REPORT OF THE PLANNING AND DEVELOPMENT DEPARTMENT FOR
APPLICATION FOR TRACK III WIRELESS COMMUNICATIONS TOWER

NOVEMBER 4, 2020

Application Sought: Track III, 194 foot Wireless Communication Tower

Application for Track III Wireless Communication Tower CTW-20-01 / Ordinance 2020-578 seeks to construct a 194 foot conventional wireless communication tower. The 7.07 acre parcel contains one residential dwelling and outbuildings. The proposed tower will be located in the northwest corner of the property.

SHEET NUMBER: C6

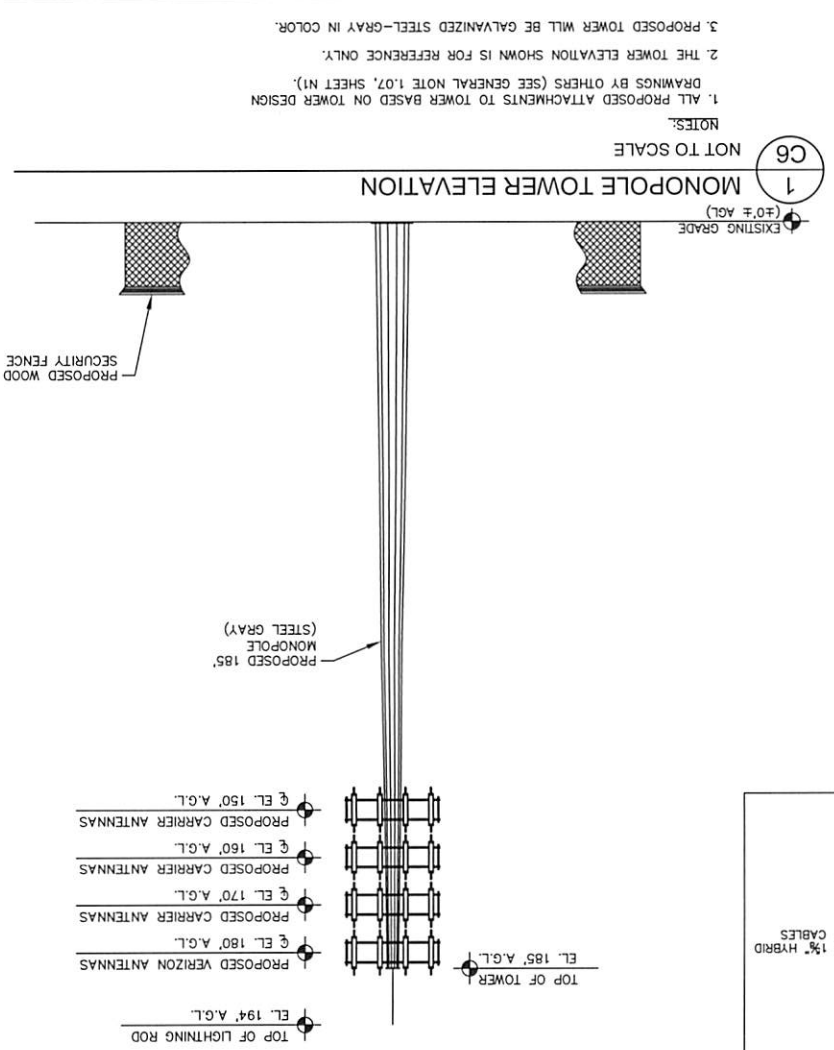
The proposed tower is to provide 5 locations for wireless providers. The drawings show four locations. **If approved, a condition should be required to revise the drawings to provide a total of five locations.**

1. The drawings shall be revised to provide for a total of five co-locations.
